P-12348-1 21440

NAME	DATE
(JINDAL)	JINDAL ALUMINIUM LTD.	DRAWN	PARVESH	11-06-2015
SYMBOL OF QUALITY		CHECKED		
AN ISO 9001 COMPANY	BANGALORE-560073 (INDIA)	APPROVED	S.S.GARG	17-06-2015
ALL DIMENSIONS ARE IN mm. ROUND OFF ALL SHARP CORNERS WITH 0.40 mm. TOLERANCES WILL BE AS PER BS:EN-755-9, UNLESS OTHERWISE SPECIFIED		SCALE		1:1
		AREA mm <sup>2</sup>		244.952
		PERIMETER mm.		472.95
PARTY'S NAME	PRAYOSHA ENTERPRISES LTD., UGANDA	WEIGHT kg,	/m	0.661
		DRAWING No. SE		ECTION No.
PARTY'S DRAWING No.	AS PER SKETCH (25mm SERIES)	P-12348-1 -		_
	0007 TO	21440 214		440 (ISSUE-2)
ALLOY & TEMPER	6063 T6			
DESCRIPTION	WINDOW SECTION (3 TRACK VERTICAL)

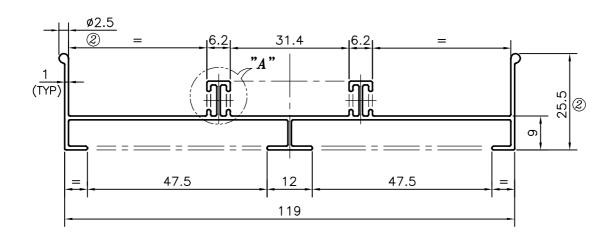
ISSUE (2) :-

Ø2.5- 2 BULB ADDED ACCORDINGLY DIMENSION ALSO CHANGED FROM 24 TO 25.5 mm AT BOTH ENDS.

SWEIGHT ALSO CHANGED FROM 0.638 kg/m. TO 0.661 kg/m.
